# Access Compliance Report

## Public Rights-of-Way

### (Curb Ramps)

Intersection ID: 43922	Main Street: NORTH_COMMUNITY_HOUSE_RD	Cross Street: JOHNSTON_RD	Location: SW
ADA ID: 23B89C75304E	Ramp Type: Perp	Initial Pass/Fail: Fail	Overall Compliance: No
		Severity Score: 8.75

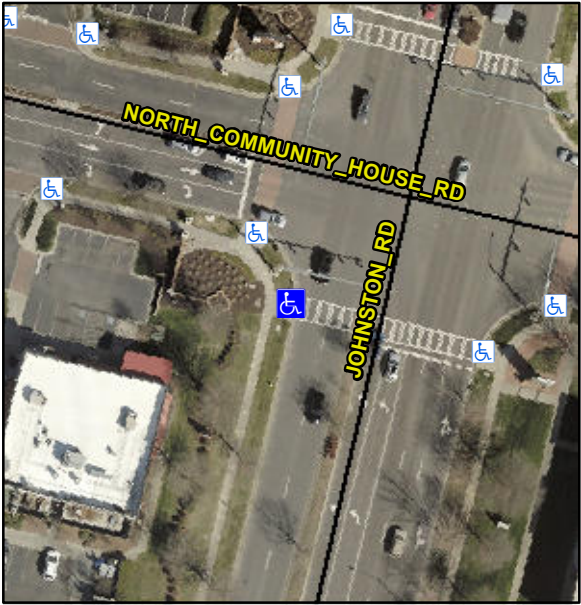
Codes/Mitigation Info/Possible Solution		Field Measurements/Component Compliance			
	Possible Solutions:				
	Remove & Replace Entire Ramp.				
	Surveyor Notes:				
	N/A				
	PROW/ADA:				
	Not Found, R304.5.1				
Street 1 Name	JOHNSTON RD				
Stop Condition-Street 2	Signal				
Street 2 Name	N/A				
Stop Condition-Street 1	N/A				
Total Cost:		\$	1850.00

Compliance	Description	Data	Compliance	Description	Data
N/A	Ramp Length (in)	118.0	Yes	Ramp Slope (%)	5.8
No	Ramp Width (in)	42.0	Yes	Ramp XSlope (%)	0.4
N/A	Flare Type LT	N/A	N/A	Flare Type RT	N/A
N/A	Flare Slope LT (%)	N/A	N/A	Flare Slope RT (%)	N/A
N/A	Flare Traversable LT?	N/A	N/A	Flare Traversable RT?	N/A
N/A	Landing Length (in)	N/A	N/A	DWS Provided?	N/A
N/A	Landing Width (in)	N/A	N/A	DWS Contrast?	N/A
N/A	Landing Slope (%)	N/A	N/A	DWS Length (in)	N/A
N/A	Landing X Slope (%)	N/A	N/A	DWS Full Width?	N/A
N/A	Landing Curb? (Y/N)	N/A	N/A	DWS Offset (in)	N/A
N/A	Shared Landing?	N/A			
N/A	Gutter Ponding?	N/A	N/A	Gutter Slope (%)	N/A
N/A	Gutter Lip Ht (in)	N/A	N/A	Gutter X Slope (%)	N/A
N/A	Painted X Walk1?	Yes	N/A	Painted X Walk2?	N/A
	X Walk 1 Direction	To SE		X Walk 2 Direction	N/A
N/A	X Walk 1 Width (in)	132.0	N/A	X Walk 2 Width (in)	N/A
	X Walk 1 Slope (%)	2.2		X Walk 2 Slope (%)	N/A
	X Walk 1 X Slope (%)	1.2		X Walk 2 X Slope (%)	N/A
